STAFF REPORT

Department of Metropolitan Development Division of Planning Current Planning Section

Case Number: 2022-CZN-872 / 2022-CVR-872
Address: 4822 East Edgewood Avenue and 5820 South Emerson Avenue
(Approximate Addresses)
Location: Perry Township, Council District #24
Petitioner: IN Indianapolis Emerson, LLC, by Joseph Calderon
Request: Rezoning of 21.232 acres from the D-A, C-1 and C-3 districts to the D-6 district to provide for single-family attached dwellings (townhomes) and multi-family residential development.

SCHEMATIC SITE PLAN FOR
IN-INDIANAPOLIS-EMERSON

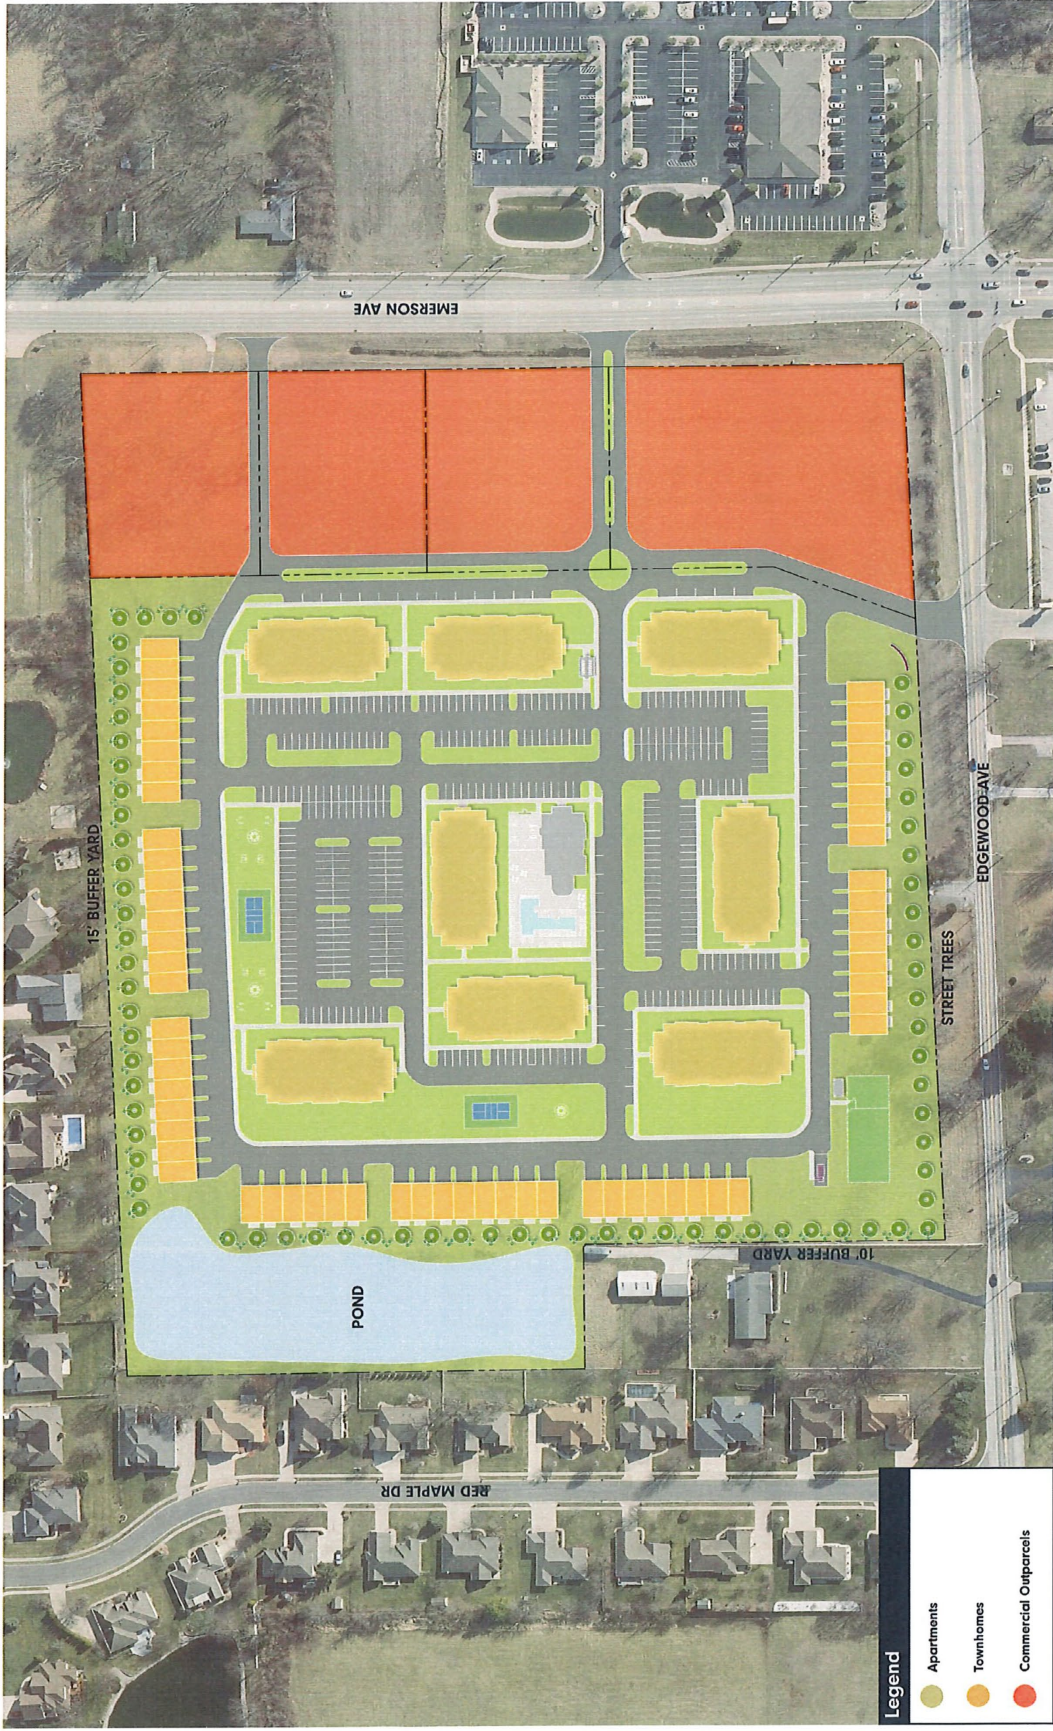
- ◇ The site plan, file-dated November 16, 2022, provides for eight townhome buildings located on the north, south and west perimeter of the site for a total of 62 units, with five three-story multi-family buildings and three four-story multi-family buildings for a total of 270 multi-family dwelling units located along South Emerson Avenue and interior to the site.

- ◇ There would be 427 surface parking spaces for the multi-family development and 186 parking spaces (surface and garage) for the townhomes.
- ◇ There would be two access drives along South Emerson Avenue and one access along the eastern portion of East Edgewood Avenue.

- ◇ Amenity spaces would include a dog park along the East Edgewood Avenue frontage and firepit / outdoor games area, interior to the site and between the townhomes and the multi-family structures. A clubhouse and swimming pool area would be centrally located. Walking trails and indoor / outdoor fitness facilities would also be available.

- ◇ This request would provide for a multi-family development building height of 49.5 feet when the Ordinance limits the building height to 45 feet in the D-6 District. Because the 49.5-foot-tall four-story structures would be located along South Emerson Avenue, staff believes the impact would be minimal on the surrounding residential uses. Furthermore, the two-story townhomes would be adjacent to the single-family dwellings and provide an appropriate buffer from the taller structures.

- ◇ Staff believes the reduction in the livability ratio is supportable because of the variety of amenities that are being proposed. Staff, however, would request that the final site plan be submitted for Administrator Approval prior to the issuance of an Improvement Location Permit that would provide more details, including, but not limited to, specific types and locations of amenities.

1. Final site plan, landscape plan and elevations shall be submitted for Administrator Approval prior to the issuance of an Improvement Location Permit.
